PRODUCT/PROCESS CHANGE NOTICE (PCN)

PCN #: **SG0703-03** DATE: **April 2, 2007**

PCN Type: Audio Codec Top Mark Format Change

Example: **STAC9200X5NAEB1X** The PCN details data location only, chip outline is not to scale and actual device marking is not in color.

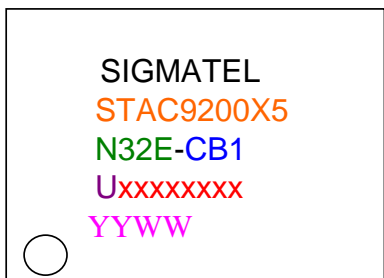
Detail of Change All 32L QFN Audio Codec devices will use the IDT standard top mark format.
There is no change to device design, process or technology.

Details:

Line 1: Replaced SIGMATEL name with IDT name

Line 2: Part number line, no change

Line 3: IDT package codes used instead of SigmaTel

Line 4: Lot code replaced by IDT format.

Line 5: removed date code and is added to the lot code line
